# Product Change Notification

## 110096 - 00

**Change Notification #:** 110096 - 00  
**Change Title:** DP43BF/DP43BFL, PCN 110096-00, Product Design, BIOS update and adding alternate component to improve manufacturability  
**Date of Publication:** June 09, 2010

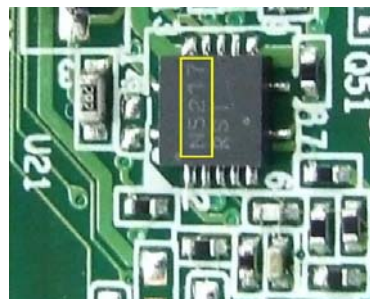
1. BIOS update to RKG4310H.86A.0082. To access release notes or a copy of the BIOS for evaluation, go to <http://downloadcenter.intel.com>
2. Added a second source vendor for the component at location U21 to ensure adequate supply. Body markings of both components are shown below:

Component marking: **TI** xxx

Component marking: **N**xxxxx
